**MONTGOMERY COUNTY HISTORIC PRESERVATION COMMISSION**  
**STAFF REPORT**

<b>Address:</b>	7300 Holly Ave., Takoma Park	<b>Meeting Date:</b>	3/8/2023
<b>Resource:</b>	Outstanding Resource <b>Takoma Park Historic District</b>	<b>Report Date:</b>	3/1/2023
<b>Applicant:</b>	Fernando Angulo	<b>Public Notice:</b>	2/22/2023
<b>Review:</b>	HAWP	<b>Tax Credit:</b>	n/a
<b>Case Number:</b>	1016595	<b>Staff:</b>	Dan Bruechert
<b>Proposal:</b>	Partial Demolition and Building Addition

The applicant proposes partial demolition and construction of an addition to the house.

**PROPOSED FRONT ELEVATION**  
 SCALE: 1/4"=1'-0" (1/A004)

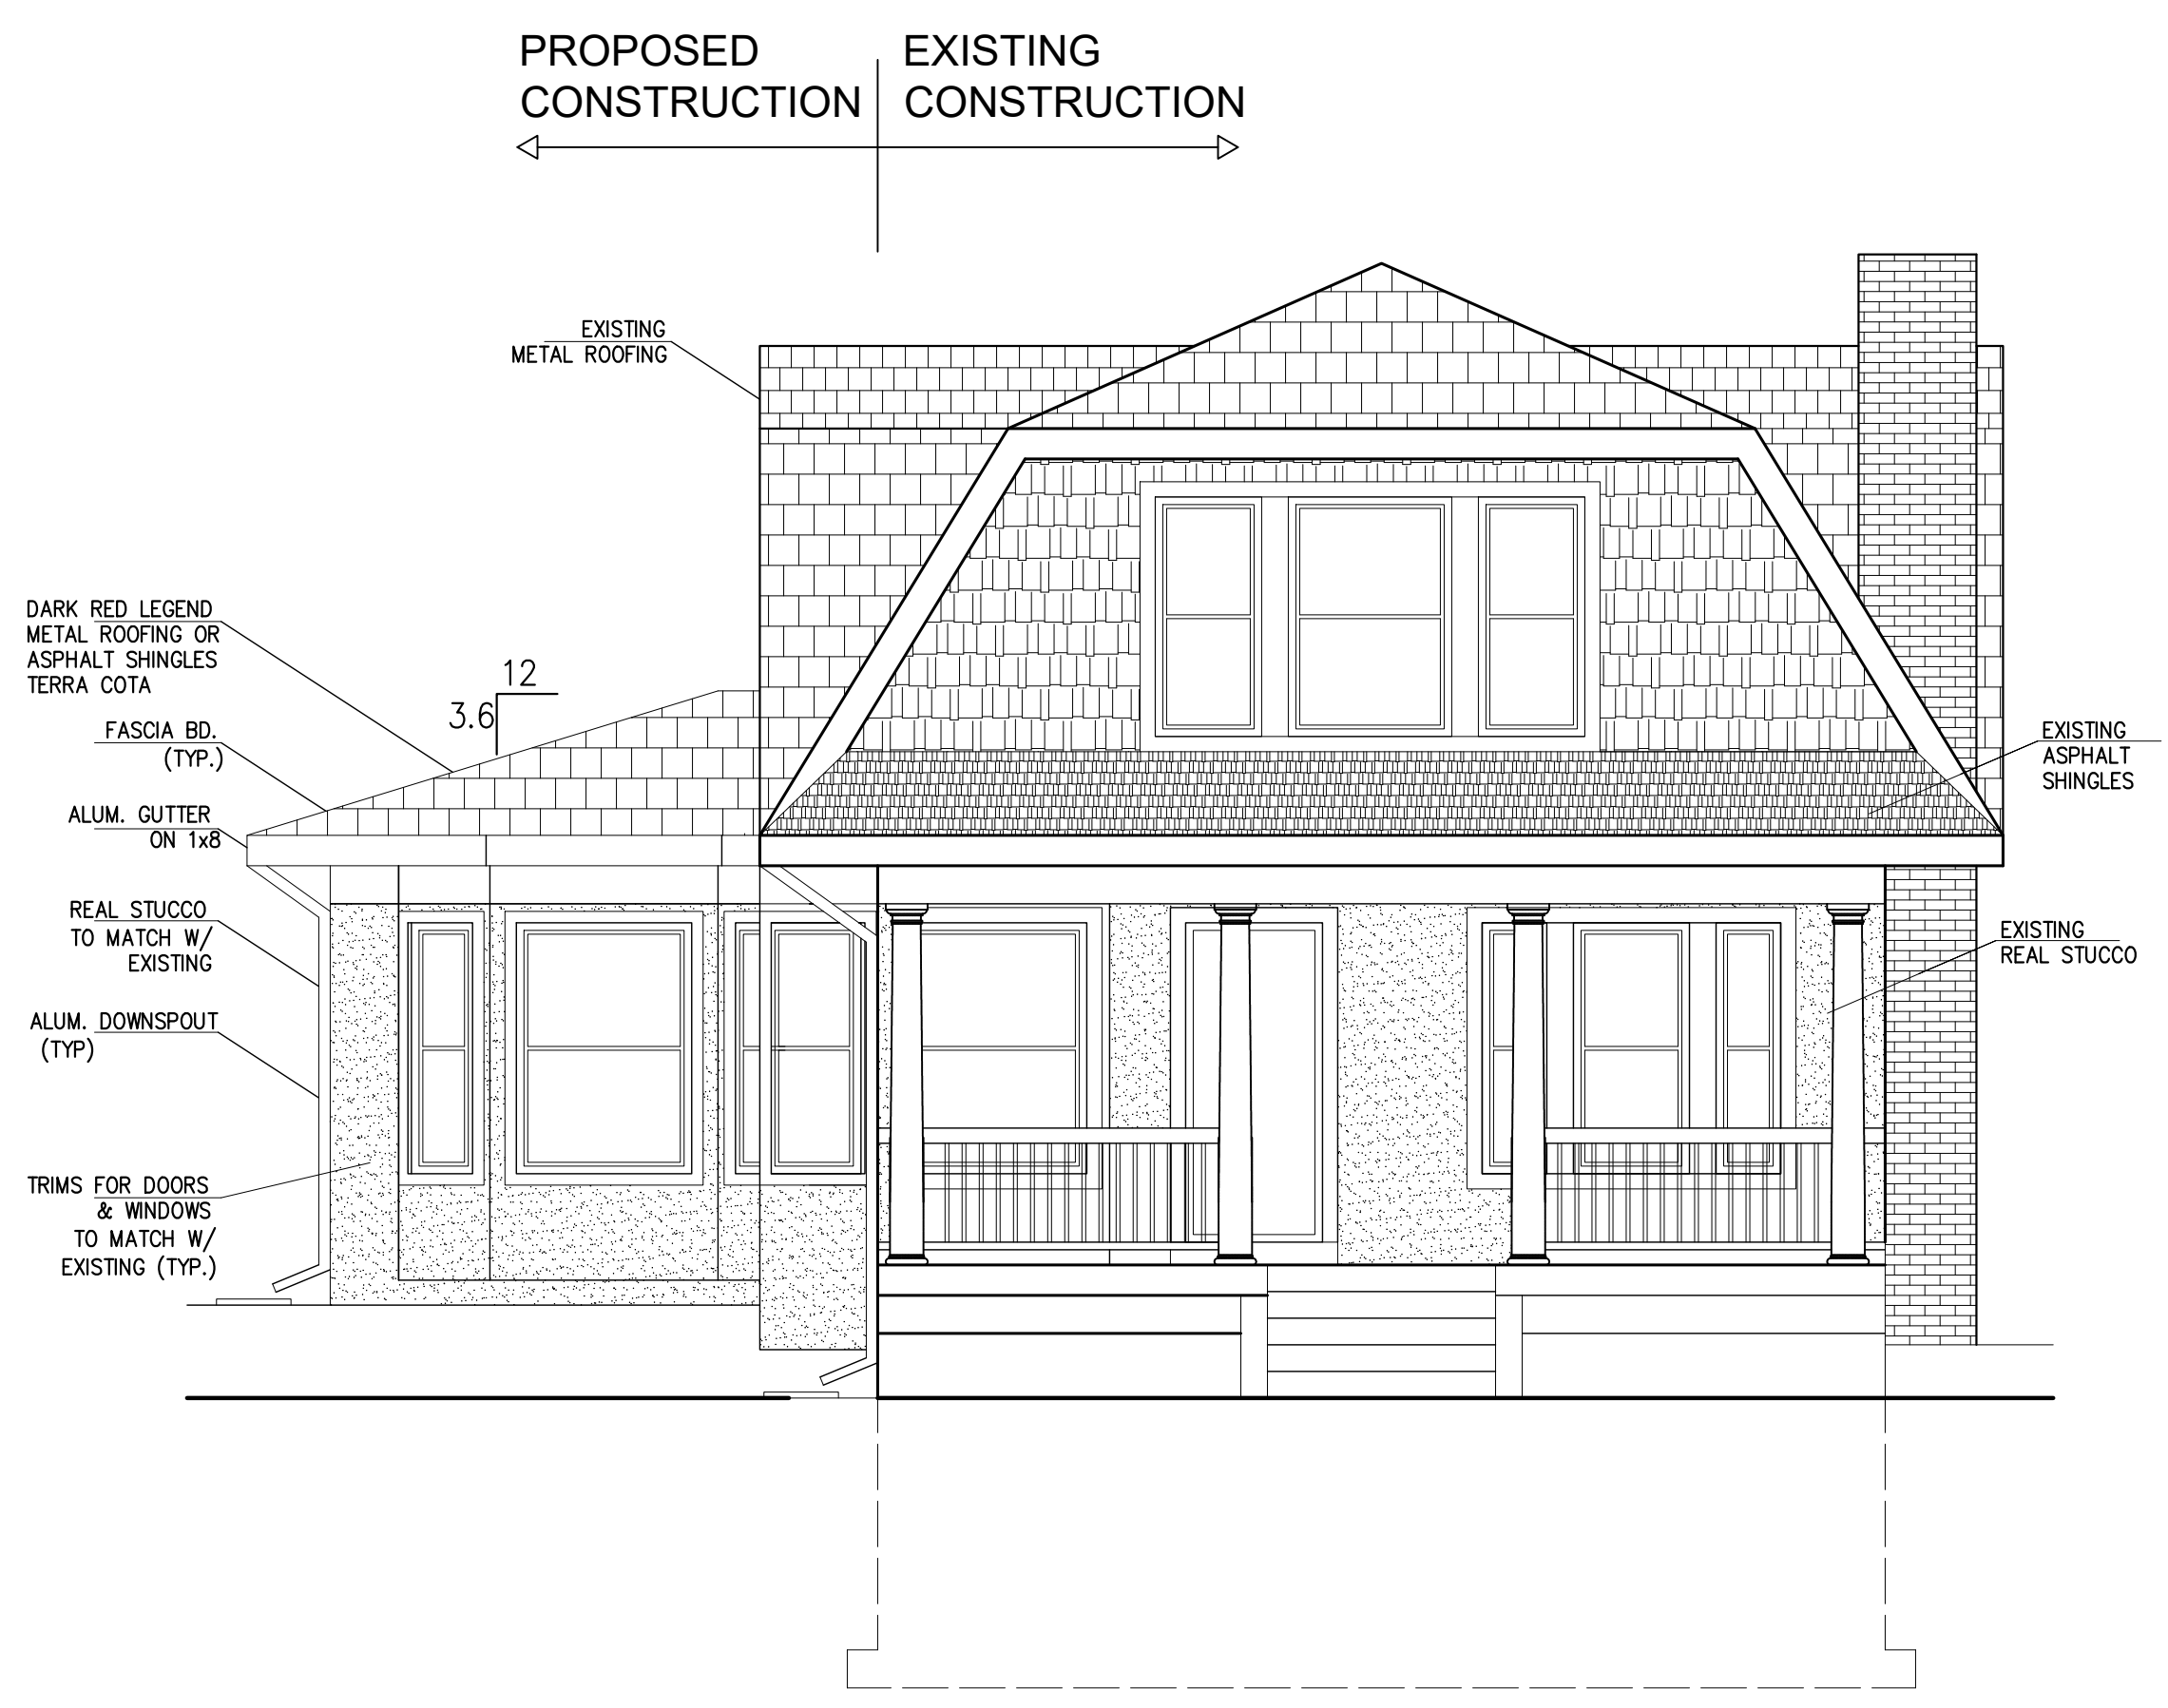
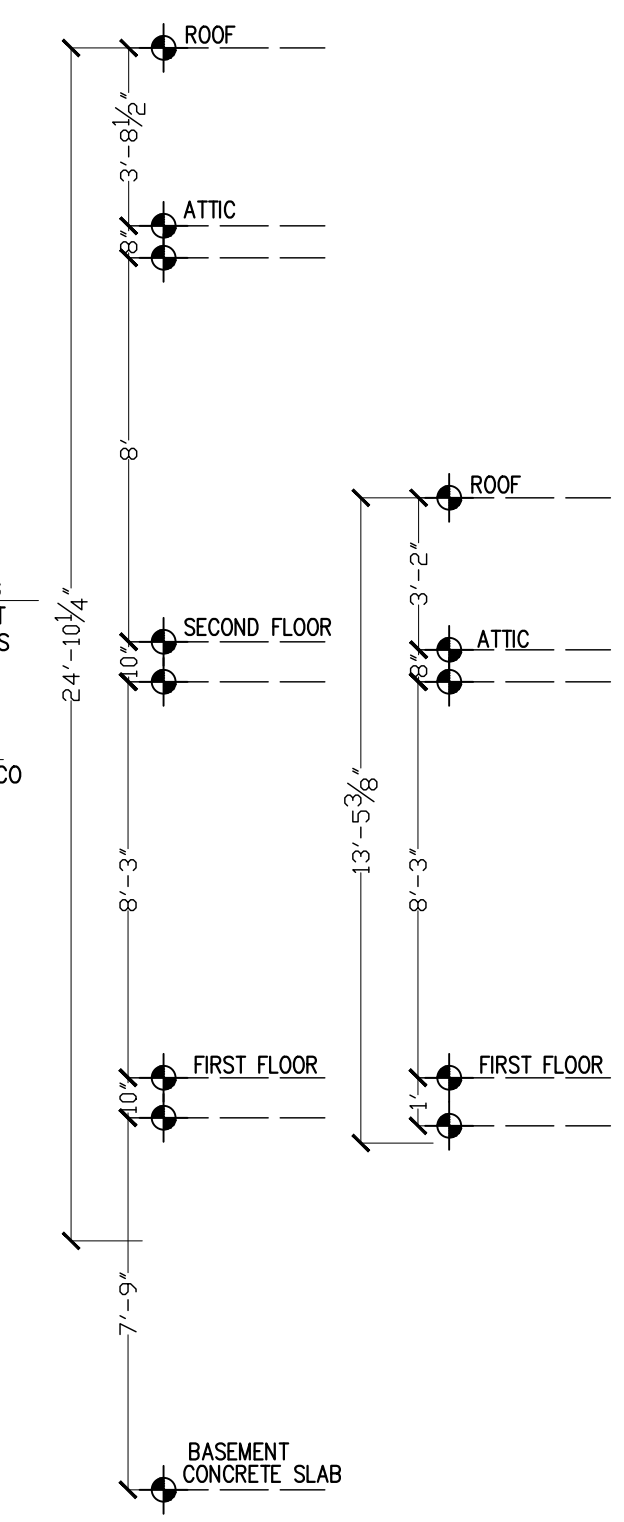
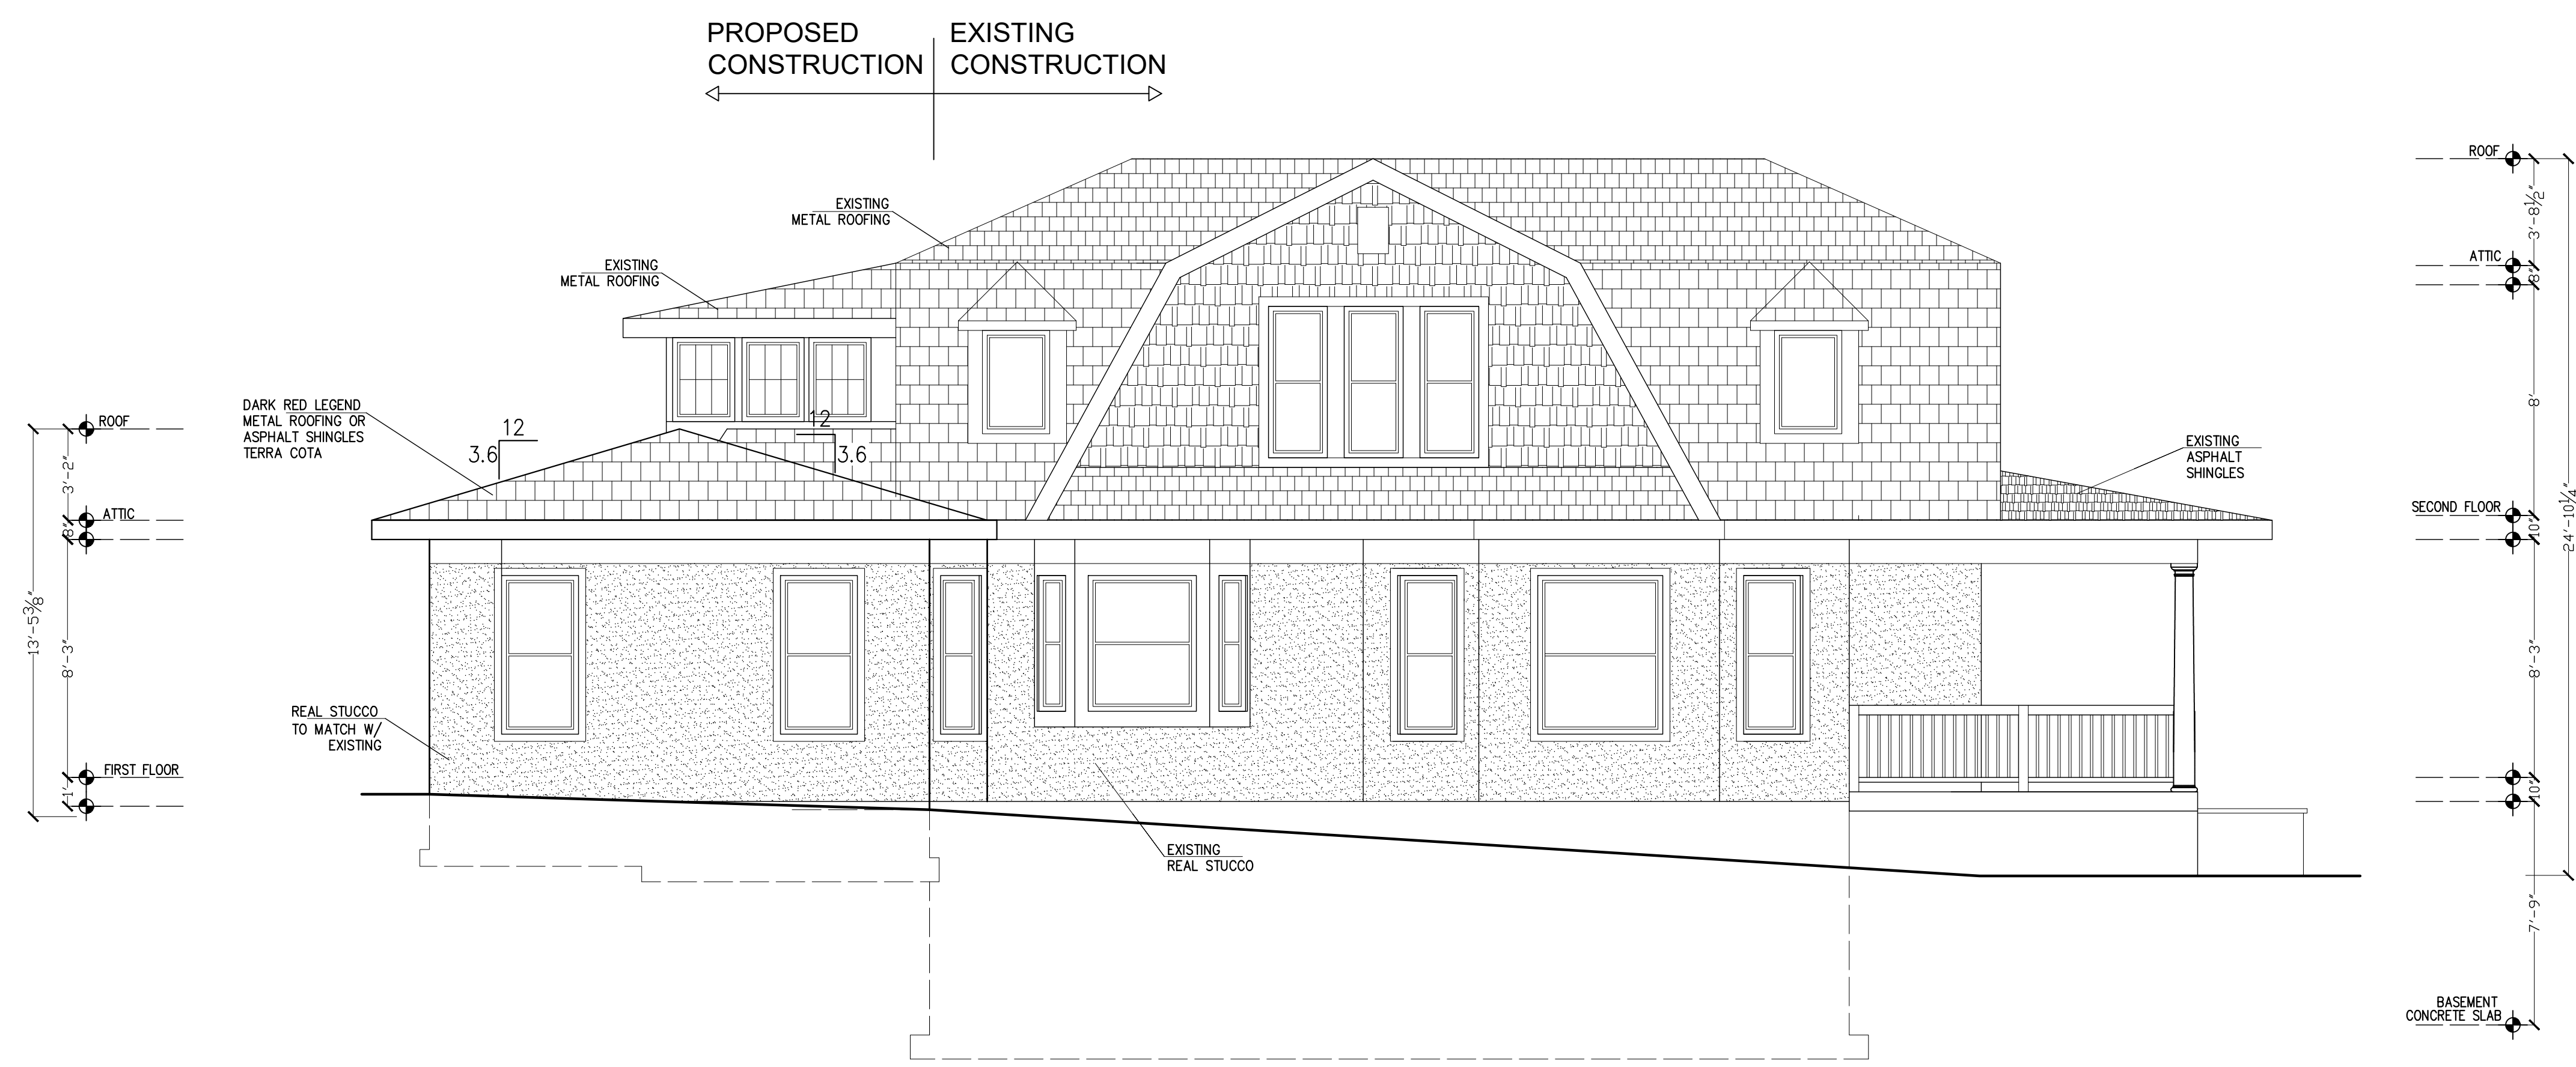
Staff finds the proposed materials are all appropriate, with one notable exception, the roof material. The elevation drawings incorrectly label the existing roof as asphalt shingle, when it is a mix of metal shingles and flat metal. Staff finds because of the visibility of the proposed addition's roof, shingles matching the historic house should be used. The *Design Guidelines* state, "Plans for all alterations should be compatible with the resource's original design; additions, specifically, should be sympathetic to existing architectural character, including massing, height, setback, and materials." The existing roof was installed in 2008 as an in-kind replacement and Staff's files identify the installed metal shingles as Berridge Victorian shingles: <https://www.berridge.com/products/shingle-systems/victorian-shingles/>. HP Staff photos show the condition of the roof prior to the installation of this roof:

Staff finds while the new shingles would initially have a shinier appearance than the existing shingles, they will patinate over time and blend in with the house architecture. While a red asphalt shingle could match the color of the existing roof and provide a dull appearance out of the box, they lack the other visual and physical qualities of the shingles and are inconsistent with the house's architecture. Staff recommends the HPC approve the HAWP under 24A-8(b)(5) and the *Design Guidelines* with the added condition that the new roofing is metal shingle to match the house. Final approval authority to verify this condition has been satisfied can be delegated to Staff.

1. The proposed asphalt shingles are inconsistent with the existing metal shingles. Metal shingles matching the appearance of the existing roof shall be installed on the addition. Final approval authority to verify this condition has been met is delegated to Staff.
